FREQUENTLY ASKED QUESTIONS

June 2024

**AMATS: Spenard Road Rehabilitation
Minnesota Drive to Benson Boulevard Project**

Typical Section

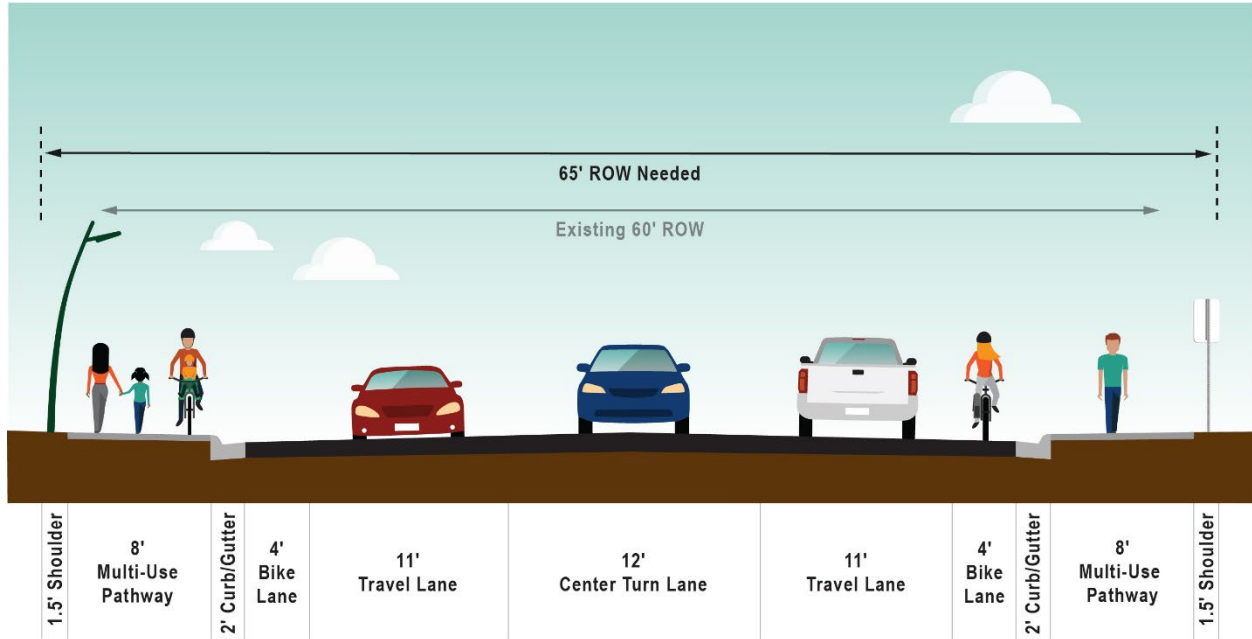
What will the road look like?

How does a three-lane typical section handle traffic compared to a four-lane typical section?

What is the width of the center left turn lane on this segment of Spenard Road?

Can the center left turn lane be reduced even more to accommodate additional non-motorized facilities?

Why does the typical section propose on-street bike lanes rather than integrating a bike lane on the sidewalk?

The typical section is shown above.

Research indicates a three-lane roadway can handle similar traffic volumes to a four-lane roadway (up to 20,000 vehicles per day), with a comparable or even improved level of service. This was observed following the completion of the “road diet” reconstruction on Arctic Boulevard, and the project team expects a similar outcome following construction of this project. Current volumes on the corridor are approximately half of the upper limit for three lane facilities.

The current design has a 12-foot center left turn lane. This is below the minimum MOA Design Criteria dimension of 14 feet.

The current design widths for non-motorized facilities meet standards and are supported by the Municipality of Anchorage (MOA). As a federally funded project, ROW acquisitions are required to follow the Uniform Relocation Assistance and Real Property Acquisition Act. The project's authority to acquire ROW is limited to what is necessary to meet adopted standards, therefore the project team cannot reduce the width of other roadway features and reallocate that space to the bike lane. Any further reduction of the center left turn lane would be used to provide additional space for roadway signs, lighting, green infrastructure, or other amenities.

- This project evaluated facilities for a wide range of cyclists, from those who may prefer a sidewalk or path to confident riders looking to quickly get across town alongside traffic.
- Bike lanes adjacent to the street can make cyclists more visible to drivers, reduce the potential for pedestrian conflicts, and allow for uninterrupted travel at higher speeds.
- The selected alternative provides both an 8-foot multi-use path and a 5.5-foot (4-foot paved) on-street bike lane. By having both facilities, cyclists can choose their preferred path based on their ability and other factors, such as road conditions.
